UNITED STATES PATENT AND TRADEMARK OFFICE

Office Action Summary

10/005,682

HYRE ET AL.

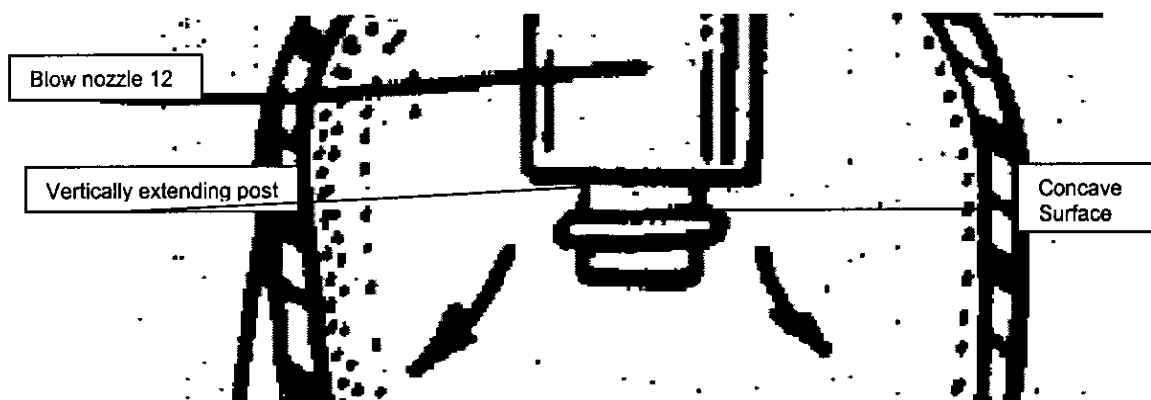
Claims 1-2 and 4 are rejected under 35 U.S.C. 103(a) as being unpatentable over Rodriguez-Wong et al US 5,807,419 ('419) in view of Virog Jr. US 4,348,167 ('167). Rodriguez-Wong discloses a glass-forming machine in order to shape a glass parison in a blowing mold (Abstract). The claimed "a blow head assembly" is '419 element 50. The claimed "support means for supporting said blow head assembly" is deemed as lock 52 of Rodriguez-Wong disclosure. The "first displacement means for displacing said support means to displace said blow head assembly between a remote up position and an advanced down position" is shown by '419 as piston element 56. The claimed blow tube displaceable between an up and down position is shown by Rodriguez-Wong as element 30. The second displacement means for displacing said blow tube from the up position down to the down position is deemed as '419's cylinder piston assembly 20. Rodriguez-Wong is silent disclosing the blowing nozzle with an "air deflector having an annular, concave surface terminating at the top with a vertically extending post for deflecting air traveling axially down the blow tube uniformly radially outwardly." However, Virog Jr discloses a conventional blowing nozzle, element 12, as shown in figure 1 having an annular air deflector with concave surface terminating at the top with a vertically extending post. As noted by Virog, air is

Applicant also argues that Virog does not disclose an annular concave surface. Said argument is found unpersuasive. As shown in the figure above, which is a blow up of the nozzle 12, it explicitly shows a concave surface formed by a doughnut shaped ring annular to the vertical extending post.
